NATIONAL TRANSPORTATION SAFETY BOARD **Investigative Hearing**

Alaska Airlines Flight 1282 Boeing 737-9, N704AL Left Mid Exit Door Plug Separation in Portland, OR January 5, 2024

Manufacturing Records and Human Performance - Attachment 2 NCR N1450293199 and NCO 145-8789-RGEN-RSHK-001NC

Attachment 2 - NCR N1450293199 and NCO 145-8789-RGEN-RSHK-001NC

ATTA	CHMENTS		
ATTACHMENT ID	TASK ADDED	Rev	EXP CNTRL	ATTACH TYPE	ATTACHMENT AUTHOR
1.jpg		0	СОМ	Graphic

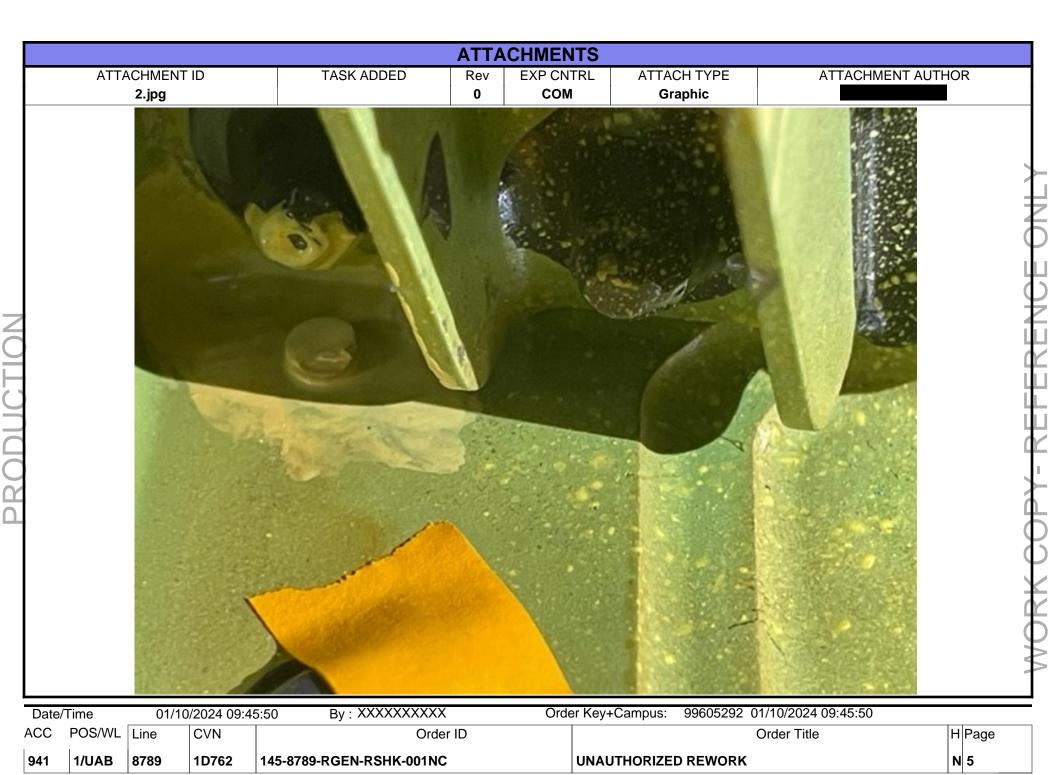
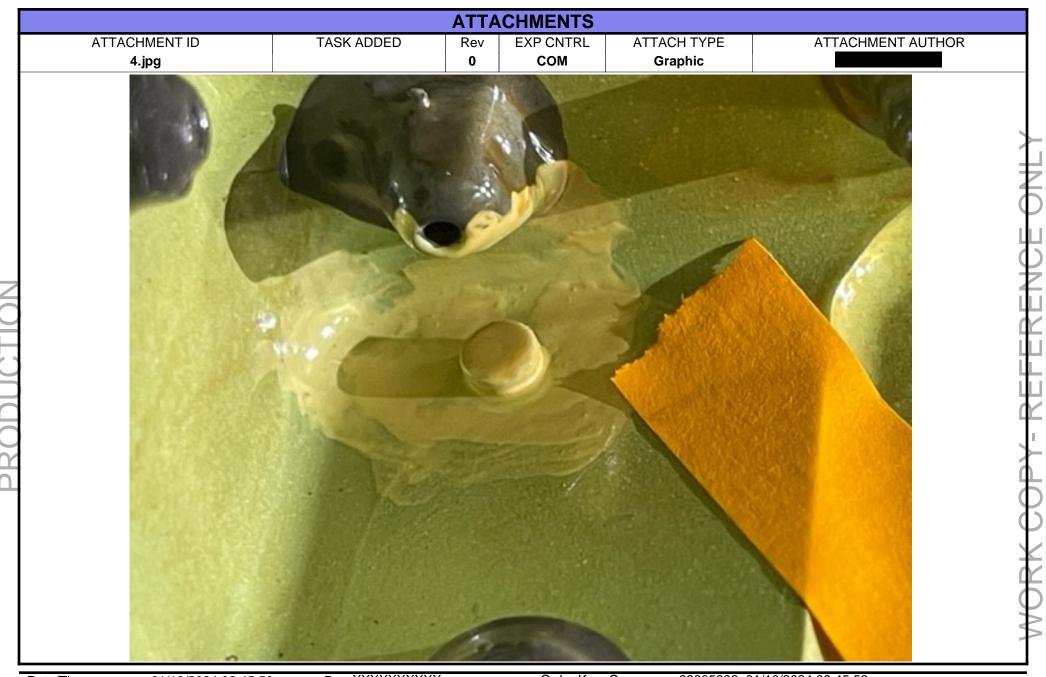
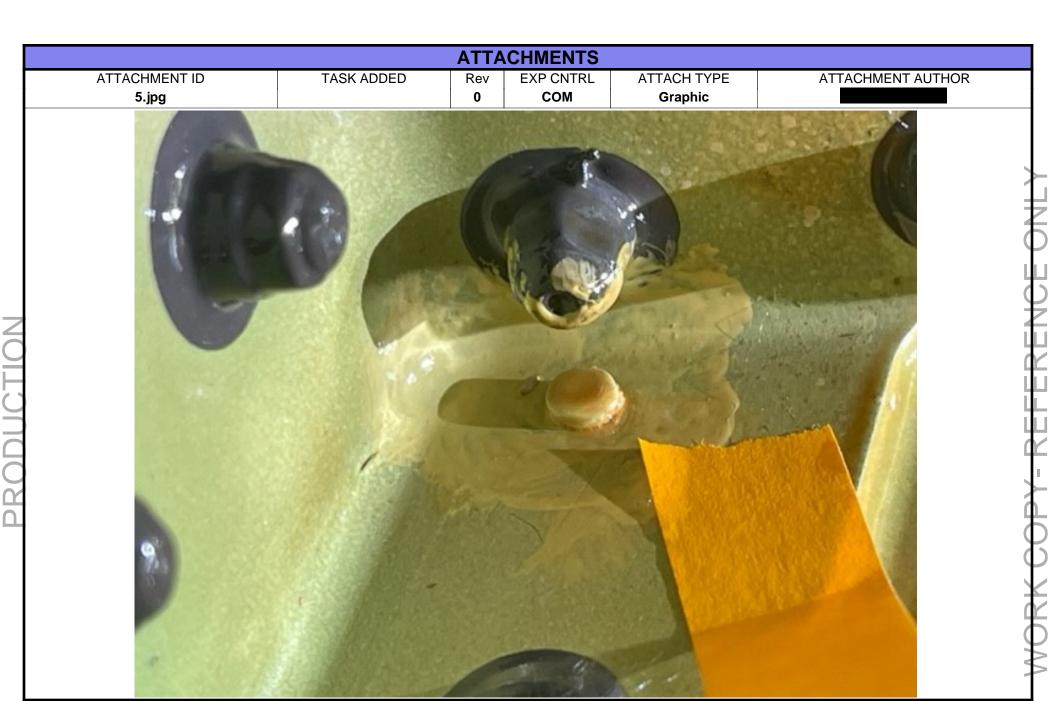
SUPPLIER STAMPED ALL INSPECTION POINTS STATING REMOVED AND REPLACED RIVETS PER (RIVETS) RIVETS WERE NOT REPLACED AND WAS JUST PAINTED OVER THERE was NO ACCESS ON THE OTHER SIDE of the part to replace those rivets and no removals were made. See attachments

UPERATION SEC	TION	1	1	
Oper	Step	Narrative	Links	Exceptions	Shop Acceptance	Quality Acceptance
10	10	NOTED RIVET BUCKTAIL DAMAGE IS ACCEPTABLE AS IS PER BAC5004-1 SECTION 11.2.2(C)	No	No	·	·
		APPLY SUPPLIER QUALITY ACCEPTANCE XXXXXX 09/10/2023 09: 35 REMOVE SUPPLIER QUALITY ACCEPTANCE XXXXXX 09/11/2023 07: 20 Damaged rivets are not acceptable and need to be removed and replaced per talks about damaged rivet heads and it's a different discrepancy painting rivets and saying that it was removed and replaced is not acceptable				
		REMOVE SUPPLIER ACCEPTANCE XXXXXX 09/11/2023 07: 21 Damaged rivets are not acceptable and need to be removed and replaced per talks about damaged rivet heads and it's a different discrepancy painting rivets and saying that it was removed and replaced is not acceptable				
		APPLY SUPPLIER ACCEPTANCE XXXXXX 09/19/2023 15:06 Rivets have been removed and replaced per rework accomplished on NCR: N1450292531				L

APPLY SUPPLIER QUALITY ACCEPTANCE XXXXXXX 09/19/2023 15:13 in concurrence with mechanic. Rivets have been removed and replaced per rework accomplished on NCR: N1450292531				
998	10	Assure all foreign objects are removed from work areas common to this order.	No	No	XXXXXX 09/19/2023 Supl Accpt	xxxxxx
		APPLY SUPPLIER ACCEPTANCE XXXXXX 09/10/2023 09: 11 REMOVE SUPPLIER ACCEPTANCE XXXXXX 09/11/2023 07: 17 Damaged rivets are not acceptable and need to be removed and replaced per				
		APPLY SUPPLIER ACCEPTANCE XXXXXXX 09/19/2023 15:07				
Date/	Time	01/10/2024 09:45:50 By: XXXXXXXXXX Order Key+0	Campus:	99605292 01/10/2024	4 09:45:50	ECV: COM
